Lincoln Park Community Club

Transition Plan - (location/priority)

Lincoln Park Community Club

City of Duluth, MN

Photo 1: View of the route from the street. There are currently steps to the main entry.

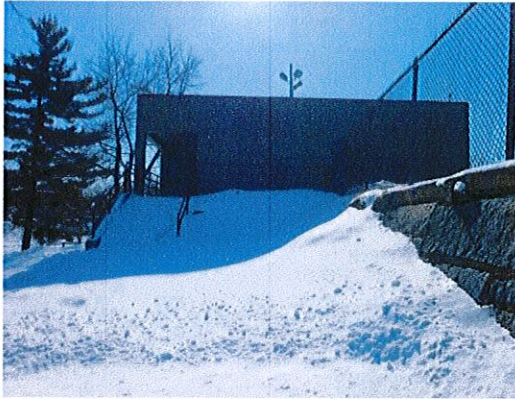
Photo 2: There is a potential accessible route via the driveway apron. Ensure the gate/barricade provides a 32" clear opening (if closed).

Location JQP # / Item #	Solution / Comments	Qty	Unit Cost	Total Cost	Priority	Estimated Compl. Date	Person Responsible	Actual Compl. Date	Actual Cost
Exterior Route 16178	<i>The accessible route from the street requires using the driveway (there are steps between the sidewalk and entry). Ensure that if the gate/barricade at the driveway is closed, a 32" wide clear opening is still provided. Photo 2.</i>	1	\$0	\$0	1				
				Priority # 1 Total					\$0

Photo 3: Patch the sidewalk to eliminate the rise in front of the building.

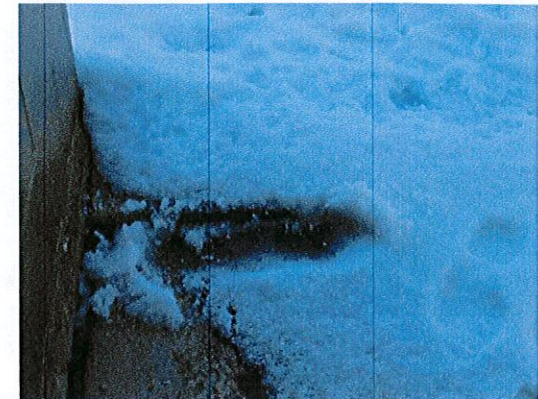
Photo 4: Typical door hardware throughout the building is a knob style. Replace the knobs with a style that does not require grasping, pinching or twisting to operate.

Photo 5: View of kitchen. There are no features of accessibility provided.

Location	Solution / Comments	Qty	Unit Cost	Total Cost	Priority	Estimated Compl. Date	Person Responsible	Actual Compl. Date	Actual Cost
JQP # / Item #									
Exterior Route									
08D1	16177	1	\$7	\$7	3				
	Modify / replace existing surface material to eliminate changes in level greater than 1/2". ANSI 303.2, Figure 303.2 <i>Photo 3.</i>								
Interior Doors									
20D	16156	3	\$250	\$750	3				
	Provide door hardware that does not require grasping, pinching or twisting to operate, such as lever. ICC / ANSI 404.2.6 <i>Photo 4.</i>

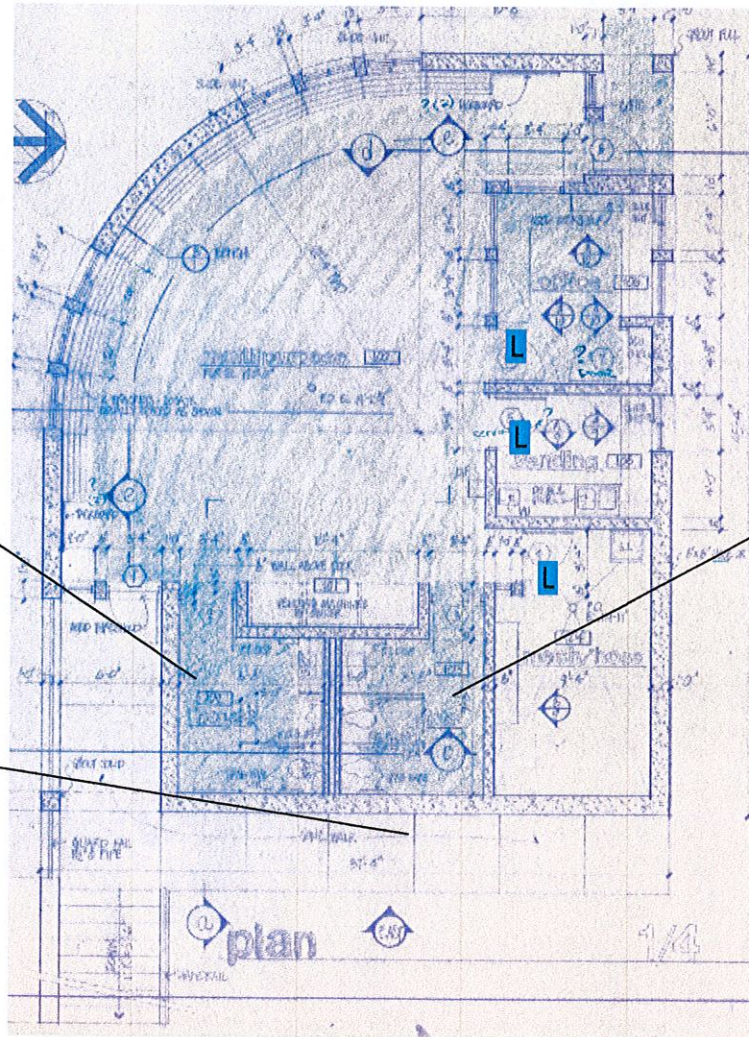
Replace grab bars
 Relocate toilet paper dispenser
 Add pulls to accessible stall door
 Replace stall door lock
 Insulate pipes at lavatory
 Replace faucet

Relocate sign
 Replace grab bars
 Relocate toilet paper dispenser
 Add pulls to accessible stall door
 Replace stall door lock
 Insulate pipes at lavatory
 Replace faucet

Eliminate rise in sidewalk

Ensure the gate/barricade at the driveway provides a 32" clear opening (if closed)

L Install door lever hardware
